### Subject: LFPCN #41279 - Glow Wire Compliance Upgrade for Holders and Blocks (cont'd)

Littelfuse Product Management would like to inform you that we are upgrading the insulation materials for our fuse holders and blocks that have VDE certification, in order to meet the enhanced glow wire requirements according to the updated standard IEC 60127-6. The new materials will be red phosphor free and halogen free. Meanwhile, we are consolidating IEC certifications with VDE.

### 659 & 660 Fuse Block Cover

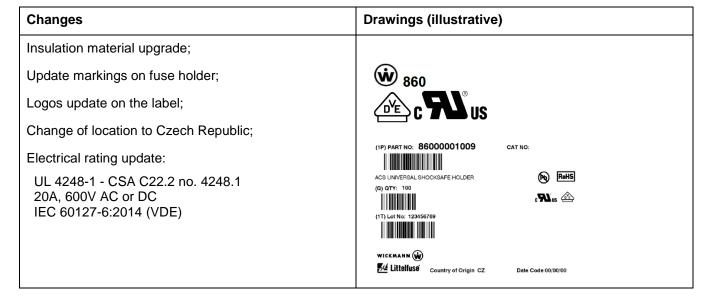
Changes	
Insulation material upgrade;

## 866 Series Enclosed Fuse Holders

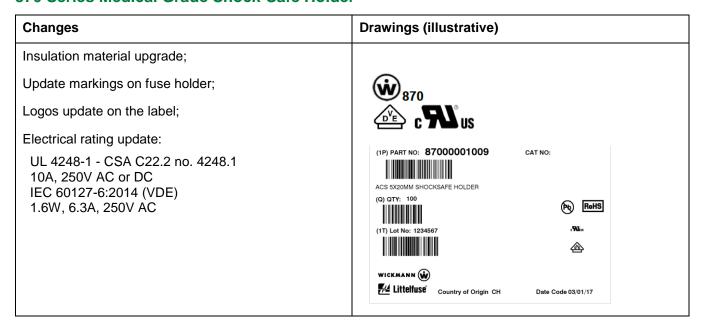
Changes	Drawings (illustrative)
Insulation material upgrade;	
Change of location to Switzerland;	
Modified the location from "CZ" to "CH" on label	
New fuse carrier design
